**The Town Of Clayton
Clayton Planning Board Agenda
Monday, May 23, 2016 @ 6:00 PM
Town Council Chambers**

**The Town Of Clayton
Clayton Planning Board Minutes
Monday, April 25, 2016 @ 6:00 PM
Town Council Chambers**

*Planning Board
May 23, 2016*

Figure 1. Monopole Tower Elevation Drawing

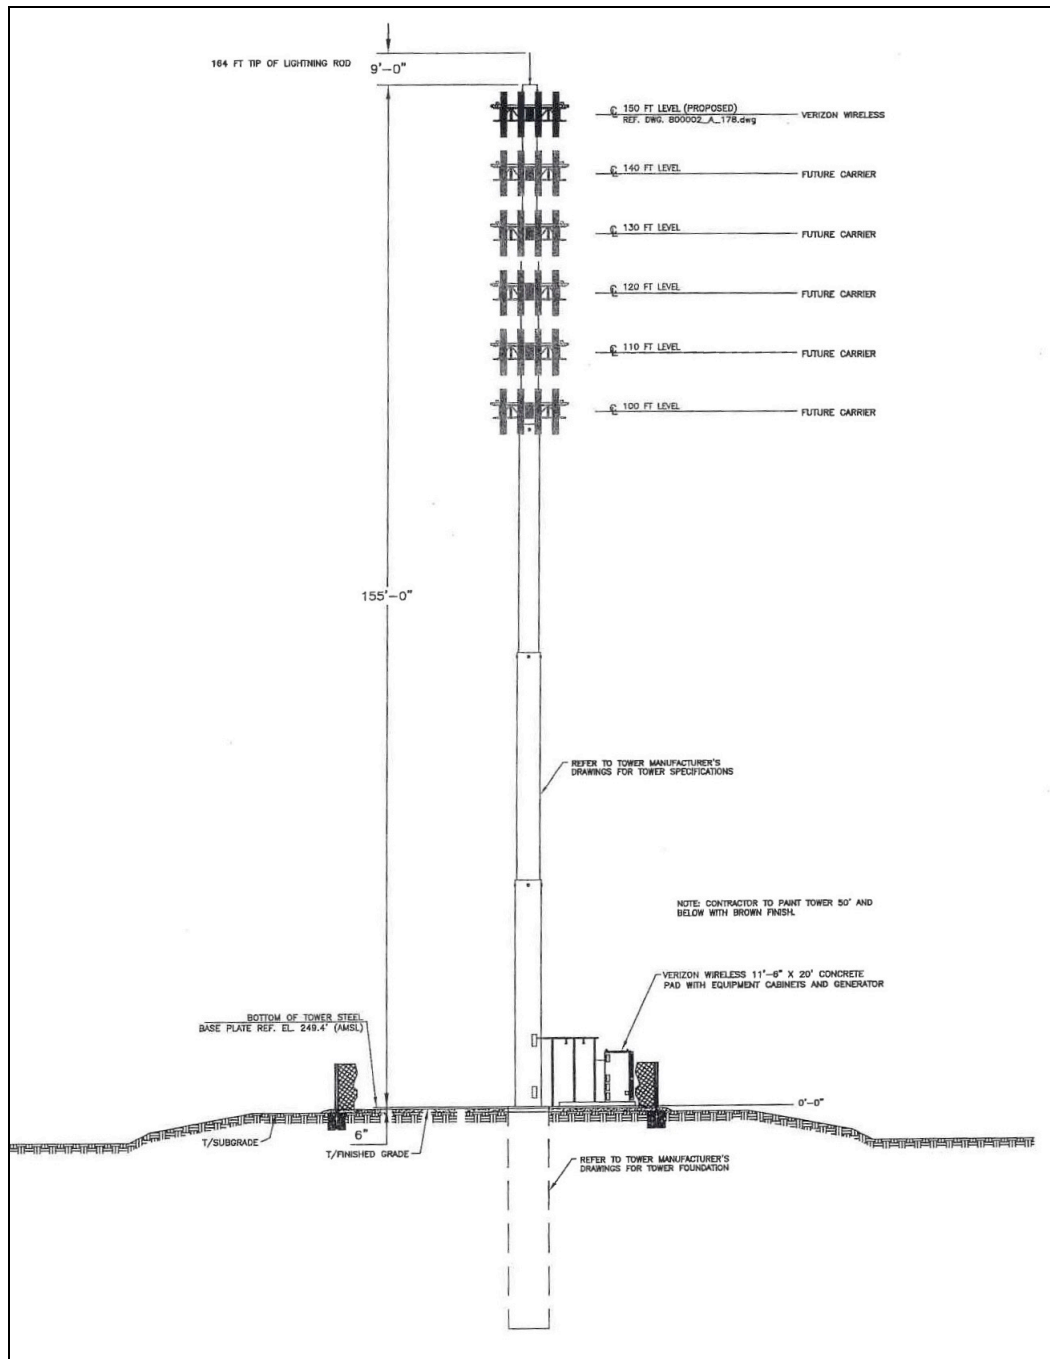
At your request, on behalf of the Town of Clayton, North Carolina ("Town"), CityScape Consultants, Inc. ("CityScape"), in its capacity as telecommunications consultant for the Town, has considered the merits of an application submitted by Crown Castle, International ("Crown") on behalf of Verizon Wireless ("Applicant") to construct a new one hundred fifty-five (155) foot monopole-type tower with a nine (9) foot top mounted lightning rod, see figure 1. In order for a new wireless support structure to qualify for special consideration under the Federal Telecommunications Act of 1996, an applicant must be a licensed or unlicensed personal communications service provider. Verizon Wireless proposes to install their antennas at the one hundred fifty (150) foot level of the proposed tower. The support structure is proposed to provide antenna space for no less than five (5) additional wireless service providers for a total of six (6) wireless service carriers. The physical location of the proposed facility is on property owned by Louis F. Pourron Life Estate and located at 3654 East Covered Bridge Road in Clayton, Johnston County, North Carolina, see figure 2.

1. The applicant shall provide a satisfactory approval from the National Environment Policy Act and the State Historical Office; and,
2. The applicant or Crown Castle International, as owner shall submit a satisfactory statement of Compliance with FCC "Good Engineering Practices" and,
3. A tower with foundation plan for a one hundred fifty-five (155) foot monopole tower with a nine (9) foot attached lightning rod, certified by a North Carolina Professional Engineer stating the structure will meet or exceed EIA/TIA-222-G standards (as amended) to include the Town's desired number of antenna arrays of like design; and,

Figure 3. Provided Search Ring

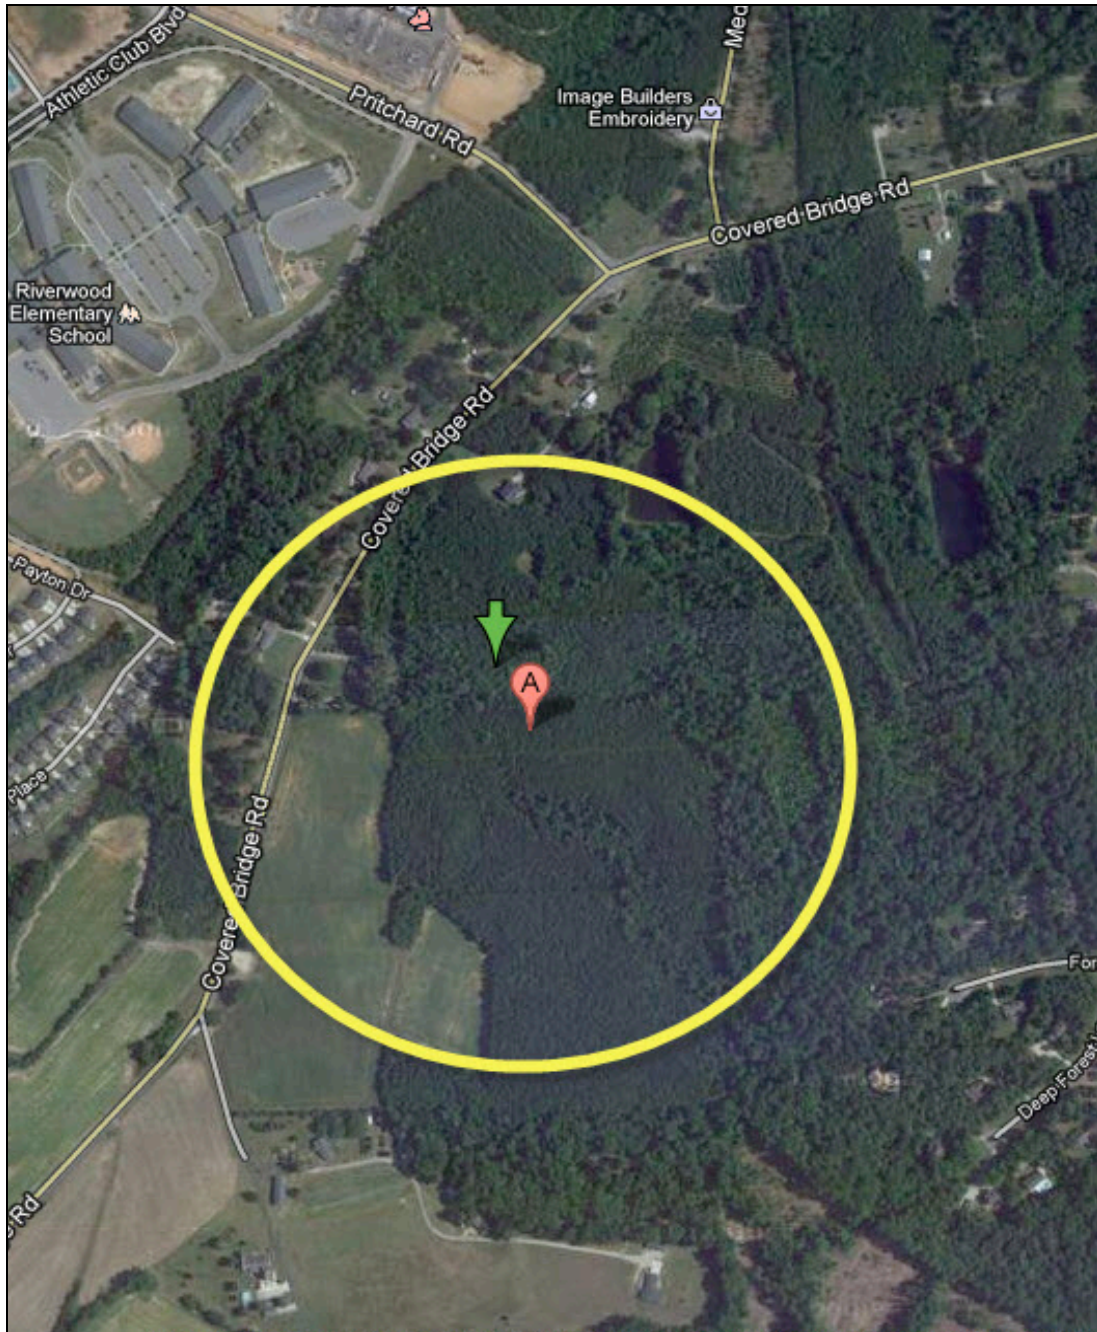
The Applicant’s submitted Search Ring is shown in *figure 3*, which identifies the optimum location needed to best meet the desired or targeted new service area. *Figure 4* represents Verizon’s current service within the general area and clearly demonstrates the current deficiencies. The projected new signal or service is shown in *figure 5*. The proposed coverage will justify the selected location but more importantly substantiates the necessary antenna elevation. Without a propagation map showing the deficiencies and then the proposed improvements there is no possible way a local jurisdiction can ascertain the merits of an application. CityScape is aware that this facility will operate in various frequency bands from 600 MHz up to 2.5 GHz and most of these frequencies are within the various Town, County and State public safety frequencies. The ordinance requires a written statement that the proposed facilities shall be in compliance, including but not limited to, interference to public safety and human exposure, which can be one statement of Compliance with FCC Good Engineering Practices. The Applicant did provide an RF exposure statement, but did not meet the specific ordinance requirements, see *figure 6*.
